**DIABLO CANYON INDEPENDENT SPENT FUEL
STORAGE INSTALLATION
SAFETY EVALUATION REPORT**

**U.S. Nuclear Regulatory Commission
Contract No. NRC-02-02-012**

**Center for Nuclear Waste Regulatory Analyses
San Antonio, Texas**

October 2003

Figure 2-1. Potential failure modes of the subsurface material under the cask-storage pad when subjected to the design-basis seismic ground motion. Both failure modes were considered in the applicant evaluation of the seismic stability of the pad.

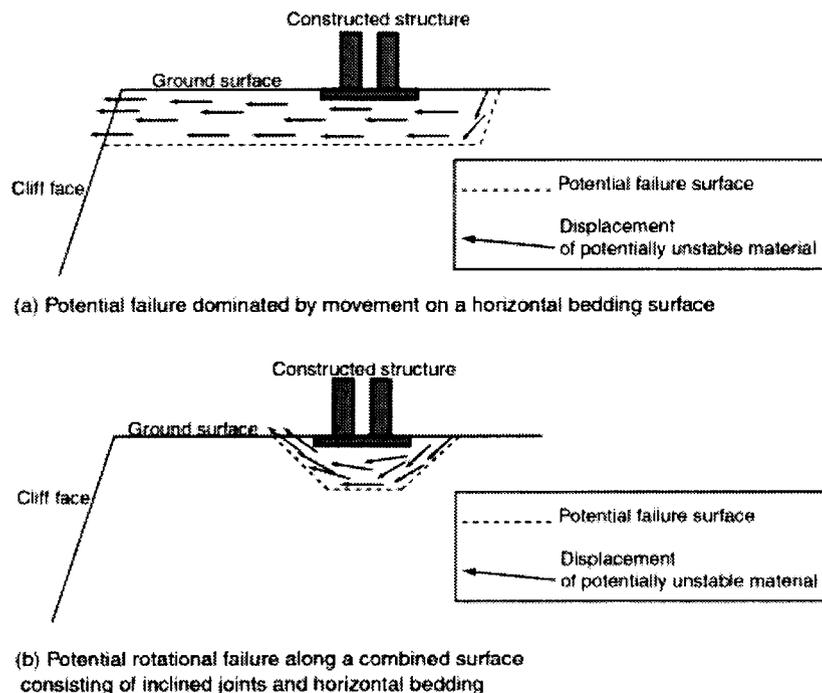
applicant⁴ to respond to staff requests. The evaluation considered the two failure modes illustrated in Figure 2-1. These potential failure modes needed to be considered because of the occurrence of near-horizontal clay beds that are significantly weaker than the surrounding rocks. The occurrence of the clay beds does not constitute a problem under static-loading states, because the static load is applied vertically and, as a result, would not cause any significant shear stress in any of the clay beds. Dynamic loading from the design-basis seismic ground motion, however, has horizontal and vertical components. The clay beds within the subsurface materials under the storage pad would, therefore, be subjected to shear stresses during an earthquake. The shear stress in the clay beds may result in a bearing-capacity failure of the storage pad following one of the two failure modes illustrated in Figure 2-1.

The applicant analysis for the horizontal-sliding failure mode [Figure 2-1(a)] is documented in PG&E Calculation GEO.DCPP.03.01, Revision 0, "Determination of Earthquake-Induced Displacements of Potential Sliding Mass Beneath DCPD ISFSI Site." The analysis considered the stability of an approximately rectangular block of rock 155.4 m [510 ft] long, 149.4 m [490 ft] wide, and 15.2 m [50 ft] thick. The top of the block includes seven ISFSI pads carrying 20 fully loaded storage casks each, and the base surface of the block is assumed to pass through a thin but continuous clay bed. The dimensions of the block were determined based on the geometry of the ISFSI pad, the canyon wall to the north of the pad, and the clay beds. The driving force considered in the analysis consists of a static representation of the lateral earthquake force calculated as αW , where W is the total weight of the block and, $\alpha = 0.43$, which is about half of the PGA for the design-basis ground motion. This evaluation of the driving force is consistent with standard practice (e.g., Kramer, 1996, p. 436). Resistance to sliding was considered as arising from the shear resistance of the clay bed at the base of the block and the shear resistance of the rock-mass on the vertical boundary surface of the block, except the canyon face. The shear resistance parameters used in the analysis are consistent with the information reviewed previously under "Geotechnical Site Characterization."

A factor of safety of 1.02 against horizontal sliding [similar to the failure mode illustrated in Figure 2-1(a)] was obtained through the analysis. This factor of safety indicates that a potential horizontal sliding of the ISFSI foundation during a design-basis earthquake cannot be ruled out based on the analysis provided by the applicant. The applicant performed an evaluation of the potential sliding displacement using the Newmark (1965) sliding-block approach. The analysis indicates that the foundation may experience a sliding displacement [Figure 2-1(a)] on the order of a few inches {approximately 1.0 cm [2.5 in]} during a design-basis earthquake. Staff concludes that such horizontal displacement would not have any significant impact on any safety function of either the pads or the storage casks.

The applicant analysis for the rotational failure mode [Figure 2-1(b)] is documented in a PG&E Calculation, "Evaluation of Potential Rotational Failure of Foundation Beneath DCPD ISFSI

Pads in Attachment 2-2.⁵ The analysis consists of evaluating the allowable bearing pressure for the pad and comparing it against the bearing pressure that may be imposed on the pad during a design-basis earthquake. The allowable bearing pressure for a shallow foundation such as the storage pad is equal to the ultimate bearing capacity, such as, the value of foundation pressure that would cause a rotational failure [e.g., Figure 2-1(b)], divided by a safety factor.
